SUBJECT: AMENDMENT NO. 23 - USE OF VANTAGE 5 FUEL  
(TAC NOS. 75262 AND 75263)

Amendment No. 23  
License No. NPF-72

Amendment No. 23  
License No. NPF-77

SAFETY EVALUATION BY THE OFFICE OF NUCLEAR REACTOR REGULATION  
RELATED TO AMENDMENT NO. 23 TO FACILITY OPERATING LICENSE NO. NPF-72  
AND AMENDMENT NO. 23 TO FACILITY OPERATING LICENSE NO. NPF-77

FIGURE 3.2-2

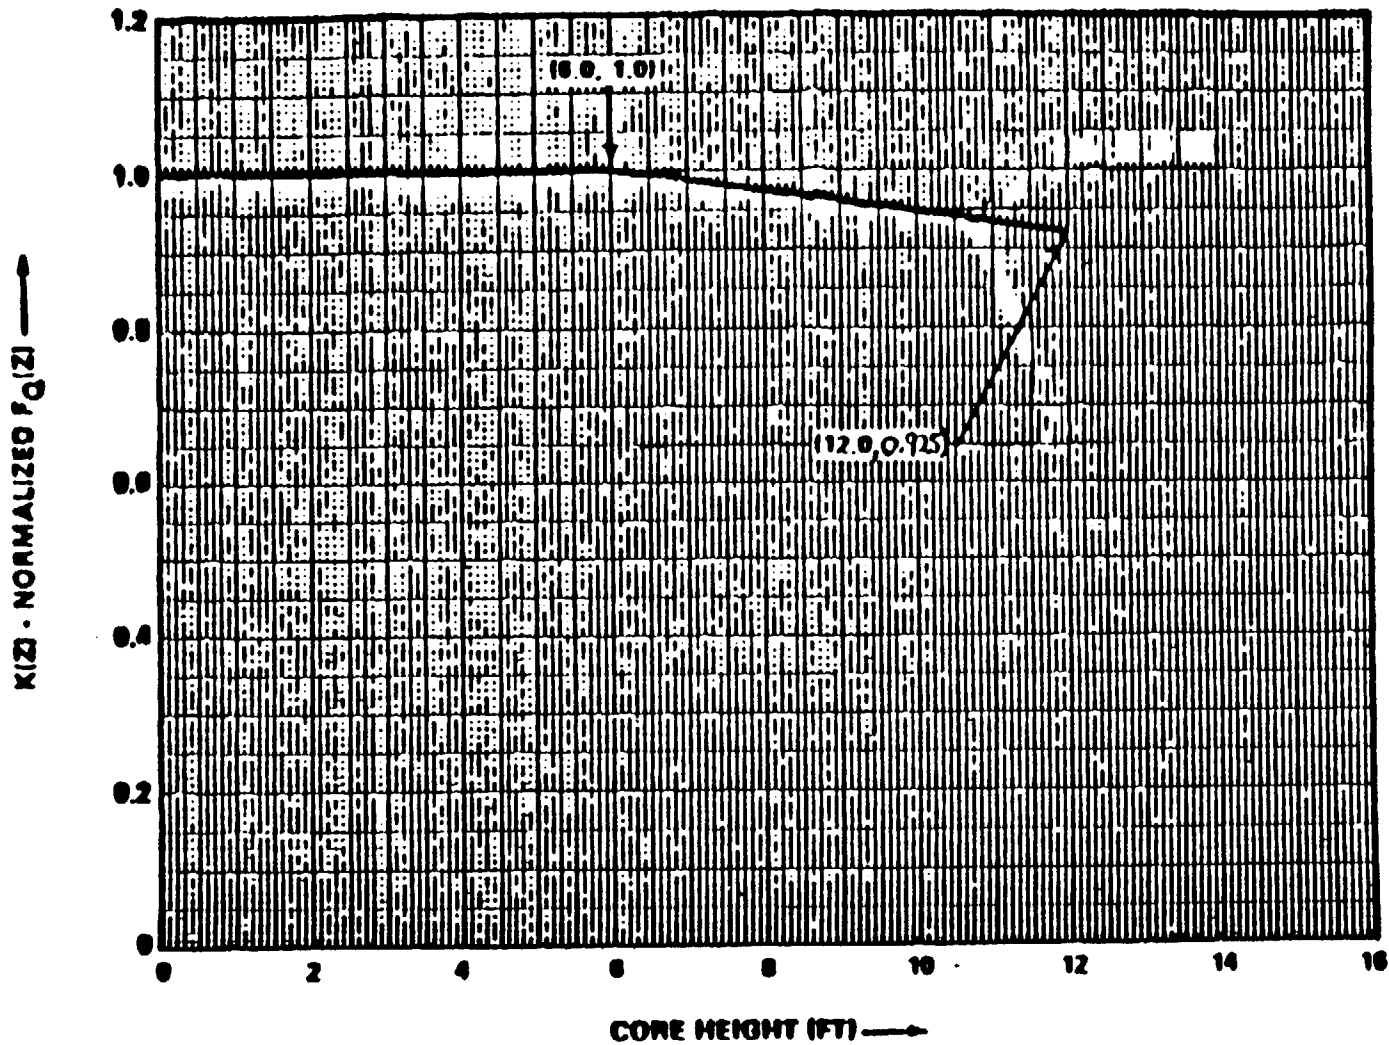
3.2.2  $F_Q(Z)$  shall be limited by the following relationships:

$$F_Q(Z) \leq \frac{[2.50]}{P} [K(Z)] \text{ for } P > 0.5, \text{ and (Unit 1 Cycle 3 and after; Unit 2 Cycle 2 and after)}$$

$$F_Q(Z) \leq [5.00] [K(Z)] \text{ for } P \leq 0.5.$$

and  $K(Z)$  is the function obtained from Figure 3.2-2 for a given core height location.

The TS changes include (1) use of the Westinghouse WRB-2 DNBR correlation for the VANTAGE 5 fuel, (2) an added maximum  $F_N^H$  of 1.65 for the VANTAGE 5 fuel, (3) an increased maximum  $F_0$  of 2.50 from 2.32, and (4) an increased control rod drop time from 2.4 to 2.7 seconds.
